# North Liberty Planning Commission

# NORTH LIBERTY PLANNING COMMISSION MEETING NOTICE AND AGENDA

To: North Liberty Planning Commission From: Dean Wheatley, Planning Director Subject: Site Plan Approval Request for industrial development at 2755 Stoner Court. (Lot 1 of I-380 Industrial Park Second Addition)

To: North Liberty Planning Commission From: Dean Wheatley, Planning Director Subject: Site Plan Approval Request (Lot 8 and part of Lot 7, Liberty's Gate Part 1)

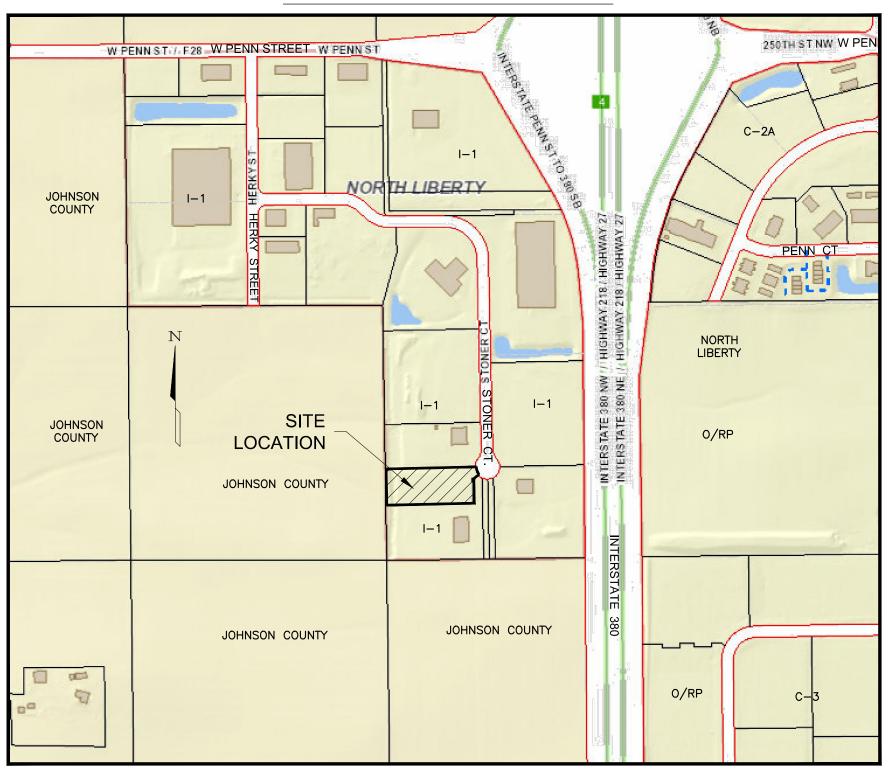
This request is to construct a 17,950 square foot construction contractor building at the southwest corner of the I-380 Industrial Park, at the south end of Stoner Court. The I-380 Industrial Park includes a number of both large and small industrial buildings.

The site layout is relatively simple, with a new large building, parking, and loading at the rear. The westerly 104' of the lot is not buildable due to the existence of a large storm water management area. The building proposed is a handsome industrial steel design that meets code requirements and is appropriate for the area.

The plan is recommended for approval.
